Product Change Notification

Product Group: OPT/Thu Apr 22, 2021/PCN-OPT-1179-2021-REV-0

Redesign of IL300 Linear optocoupler product series

Details of Changes to IL300 Series Addressed in PCN OMV-1179-2021

<table><tr><th>NEW</th><th>CURRENT</th></tr><tr><td colspan="2">Package Dimension: The package still conforms to the JEDEC standard, some of the dimensions have slight changes.</td></tr></table>

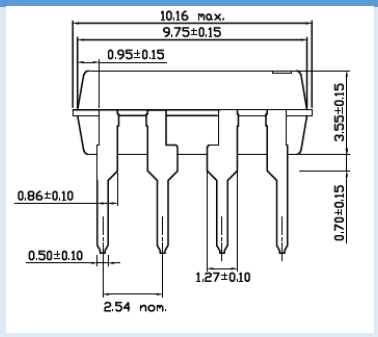
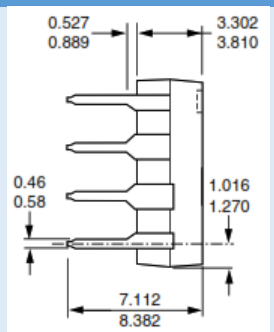
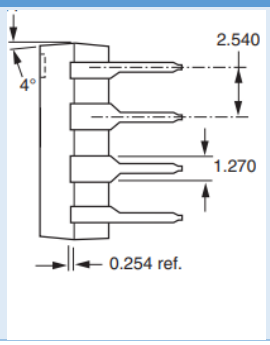
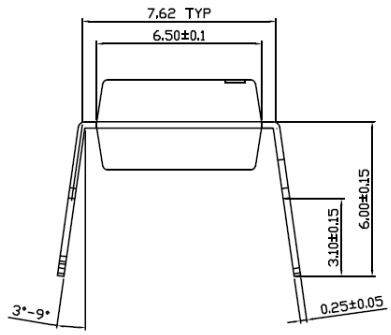
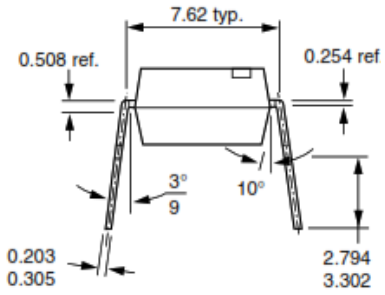
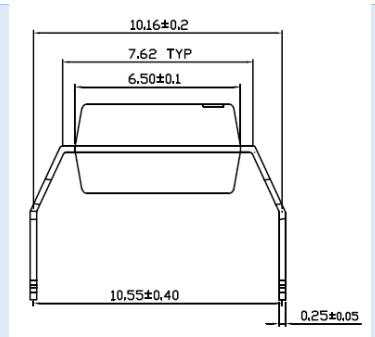
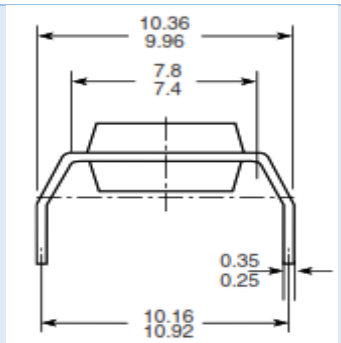
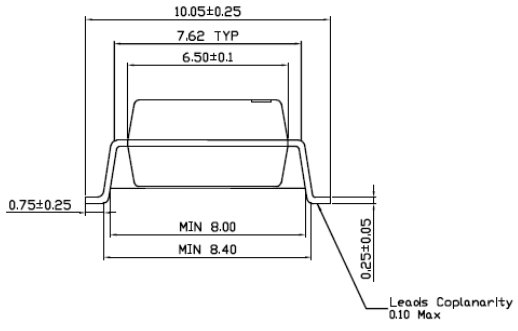
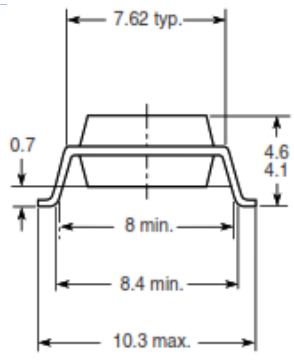
The package has been redesigned resulting in several changes. The most notable of these changes is the colour of the outer molding compound. Less noticeable is the change in construction and the change in package dimensions.

New	Current
Forward Current vs. Forward voltage	Forward Current vs. Forward voltage

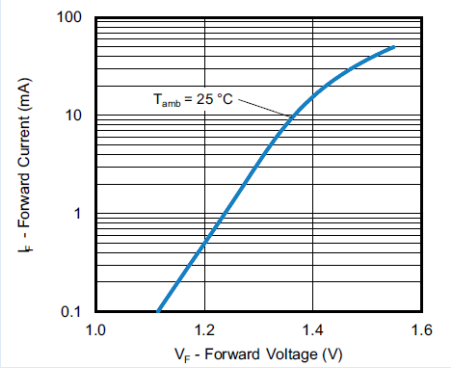
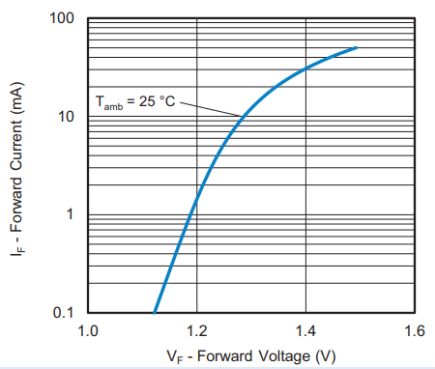
Detailed product characterization has been performed on this series of products. Some slight changes in electrical parameters and performance were observed.
